Comment Set D.10: Brian A. Smith

Proposed Antelope-Pardee 500-kV Transmission Project

Response to Comment Set D.10: Brian A. Smith

BELCARO COMMUNITY

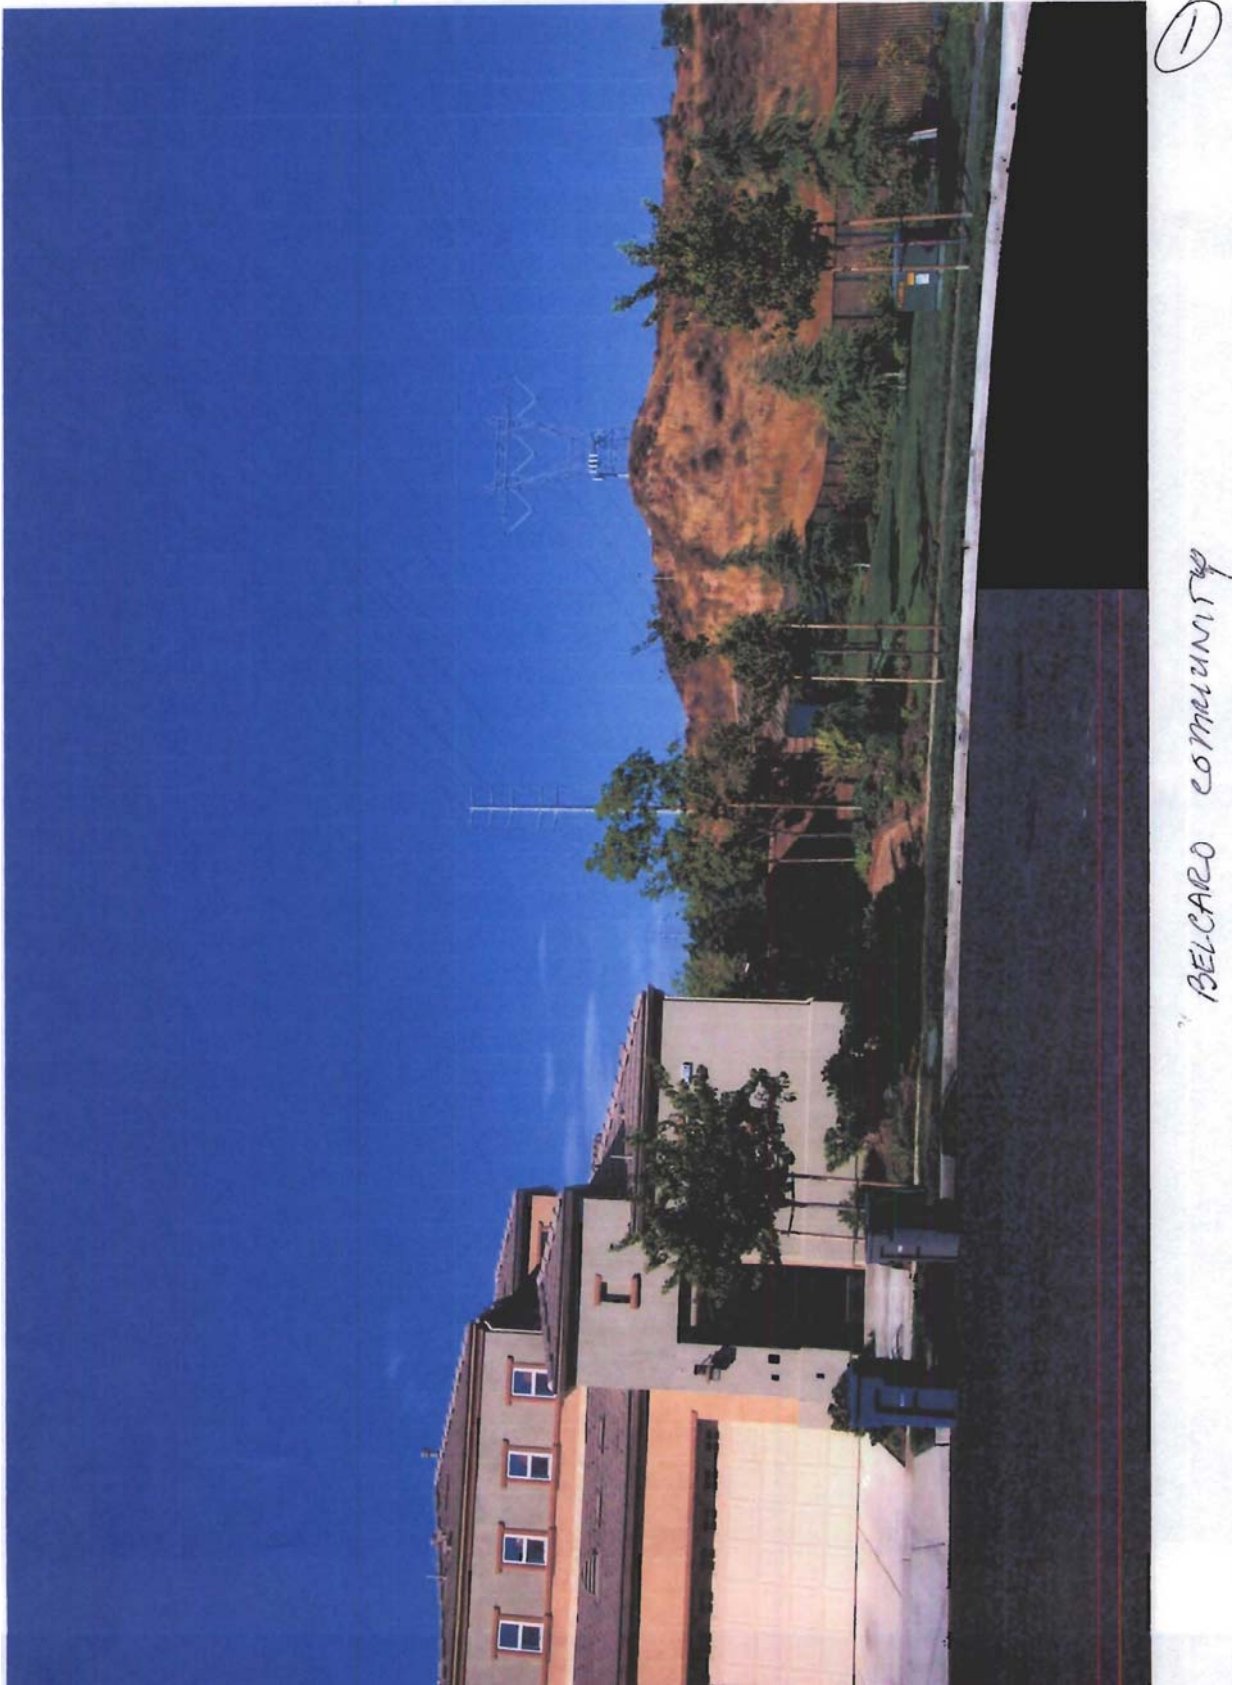
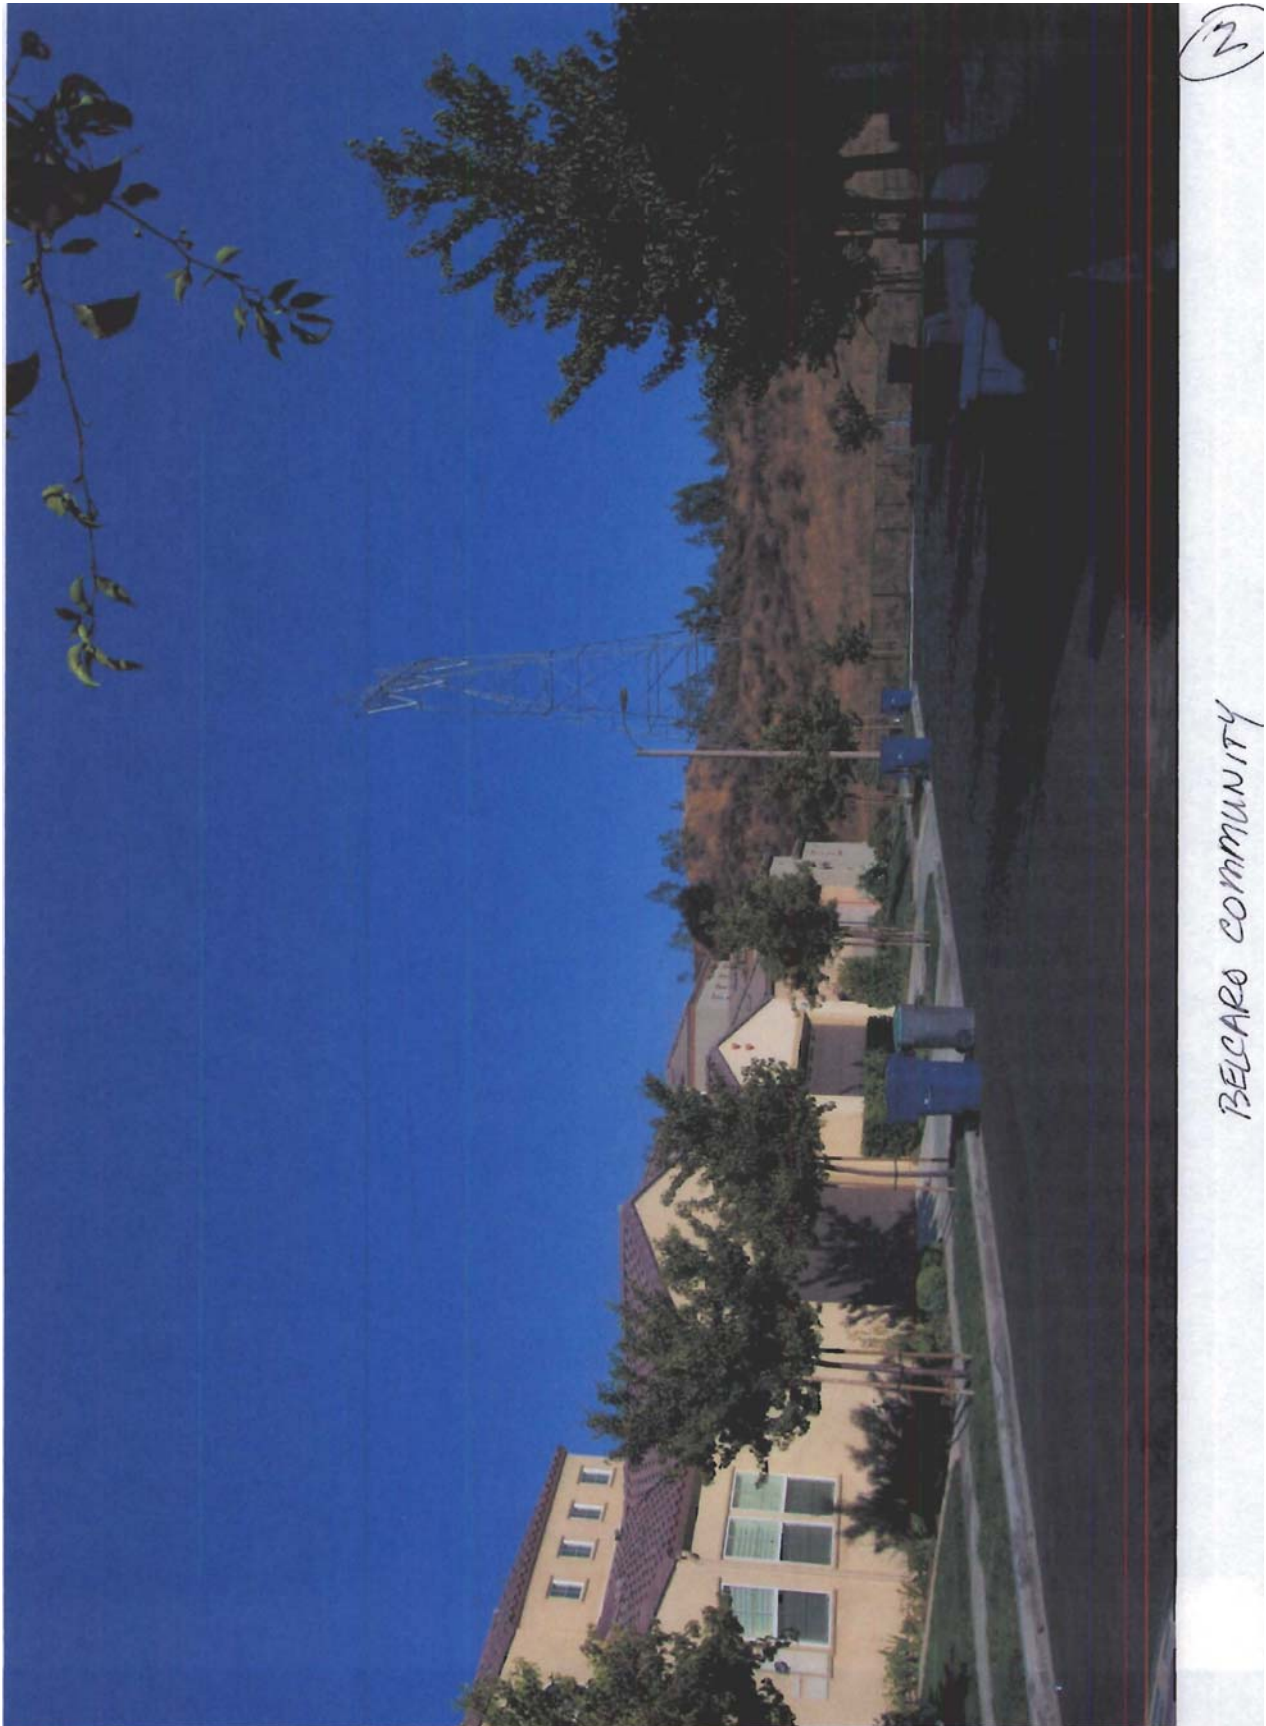
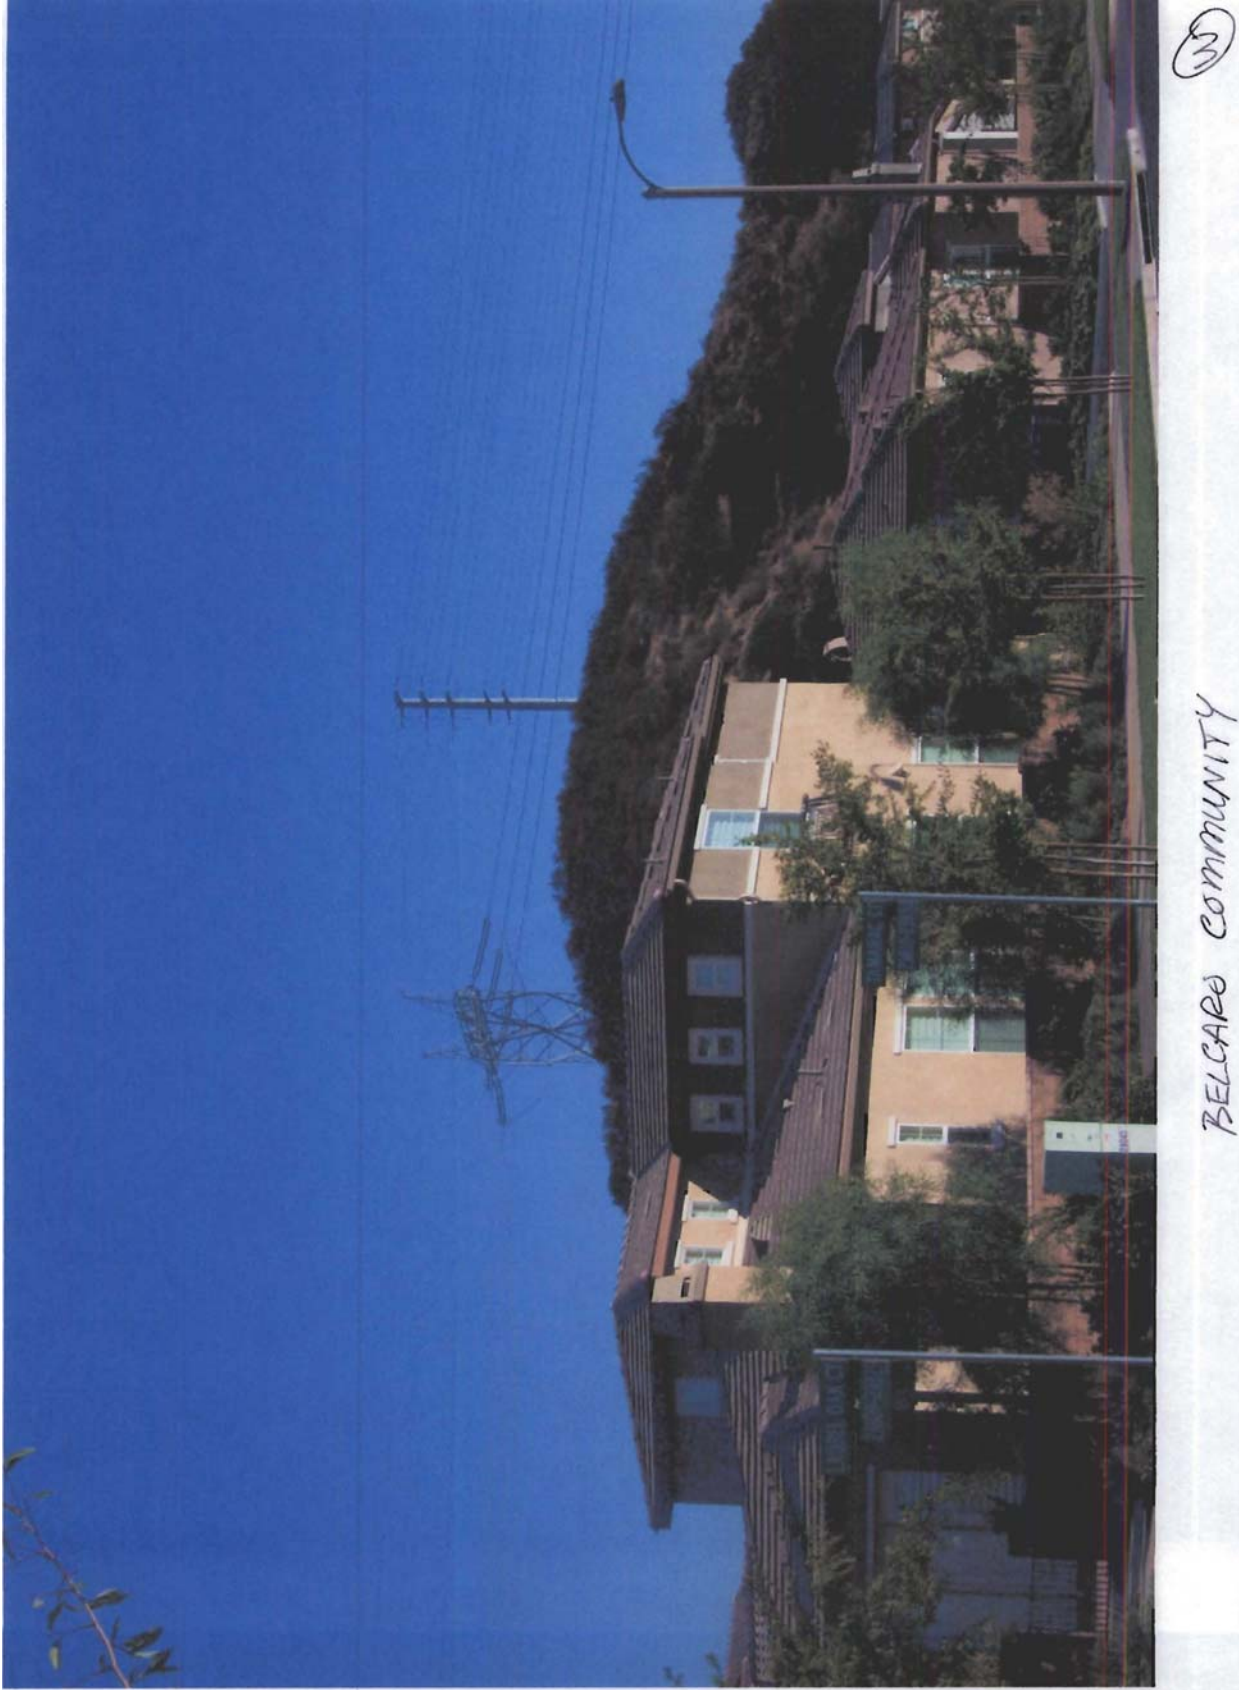
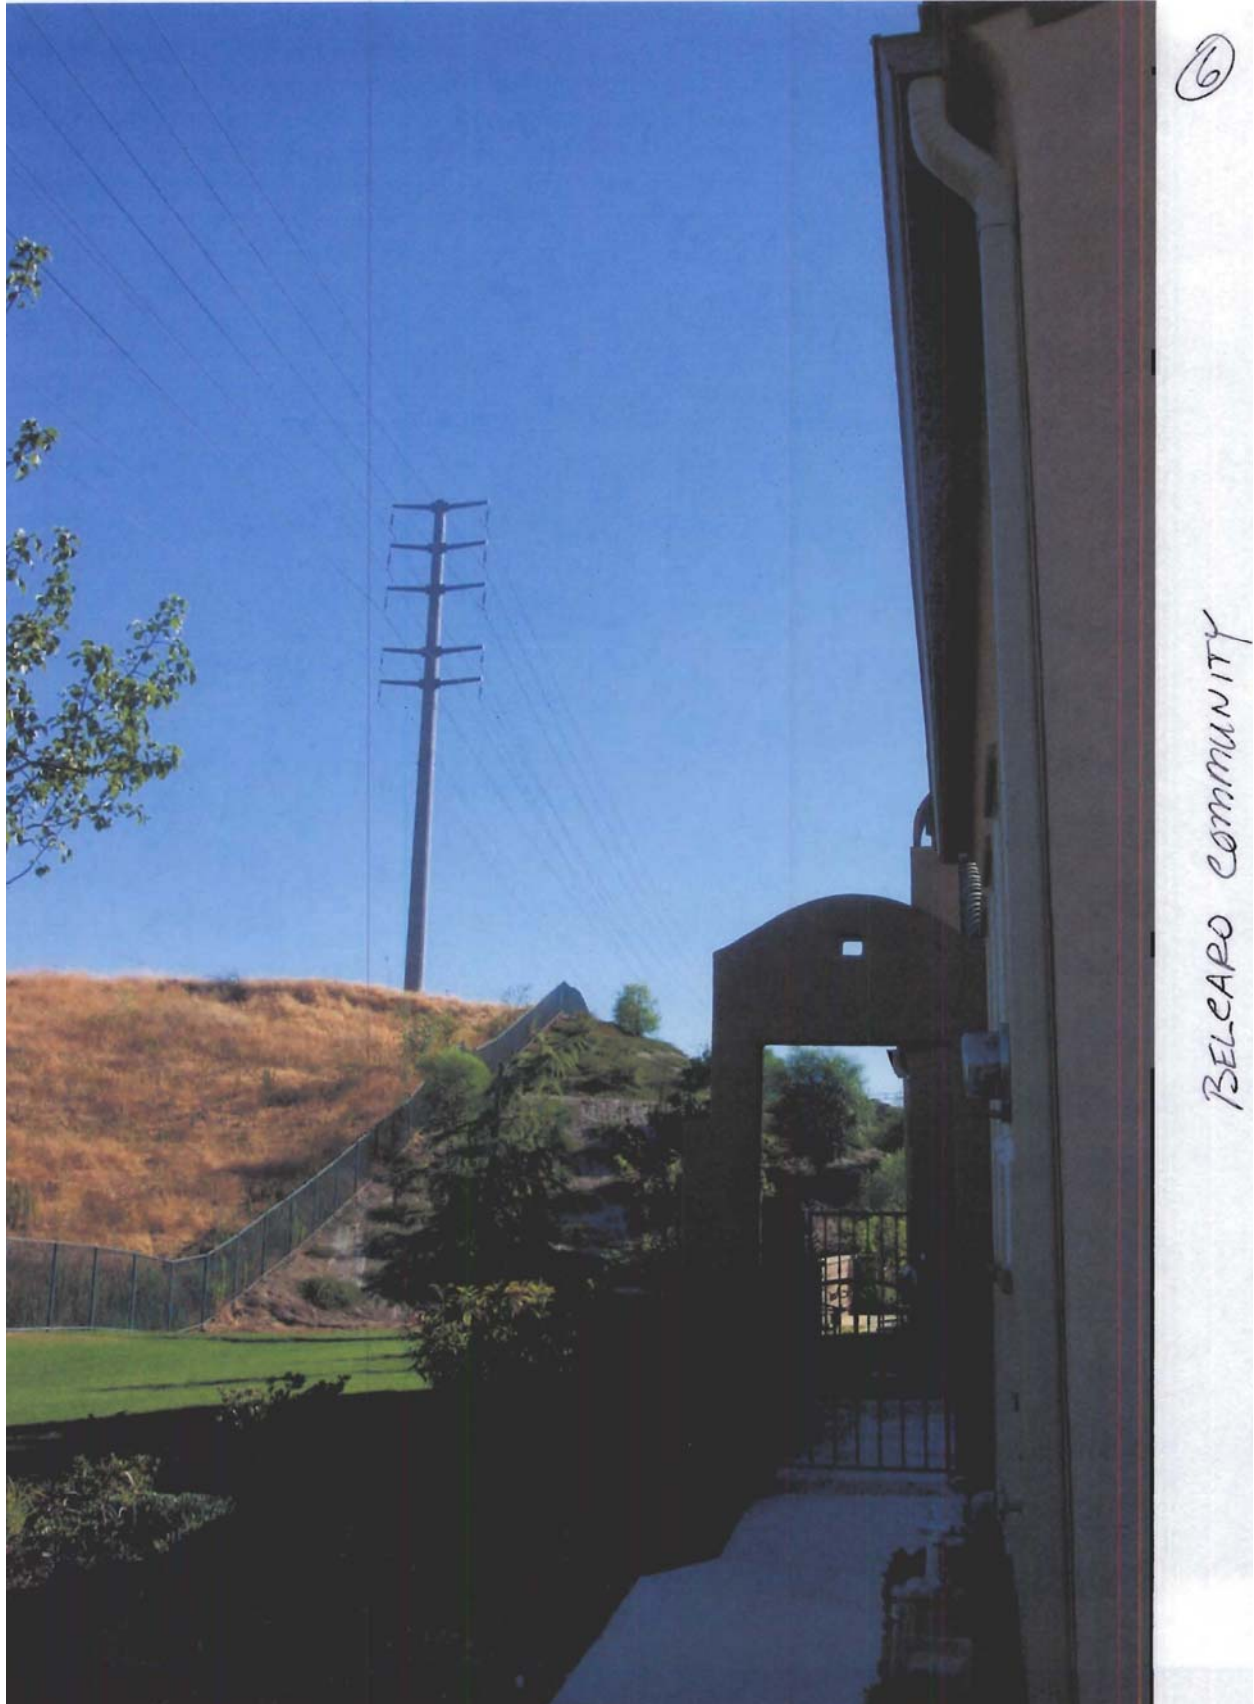
mono pole towers. This will reduce the visual impact rather than the existing proposals that will have negative impact on the views on Mile 22.3 through mile 25.6. I also believe the EIR does not properly address the EMF impact of alternative no 3 in the area next to populated areas between mile 22.3 and mile 25.6. The EIR shows ~~no EMF~~ fails to show an EMF cross section effect for Alternative 3. I believe that the visual impact portion of the EIR should include a study of the effects of both the proposal and alternative 3 ~~for~~ on our neighborhood. (THE COMMUNITY IS NAMED BELCARO)

D.10-2
cont.

D.10-3

D.10-4

D.10-2 Please see photographs and visual simulations at the end of Section C.15. Please refer to visual simulations of KOP 10, which is representative and characteristic of many views within the suburban neighborhoods of the Santa Clarita vicinity. Simulations of KOP 10 show (1) existing conditions; (2) the proposed Project with double-circuit lattice steel towers; (3) visual mitigations with double-circuit tubular steel poles; and (4) Alternative 3 with a second set of 500-kV lattice steel towers.

D.10-4 As noted in the responses to Comments D.10-1 and D.10-2, KOP 10 was selected because it is representative and characteristic of many views within the suburban neighborhoods of the Santa Clarita vicinity. It is impractical to provide simulations from every affected neighborhood along the proposed and alternative routes, and conclusions about visual impacts and proposed mitigation measures would not change if visual simulations were prepared for the Belcaro Development.
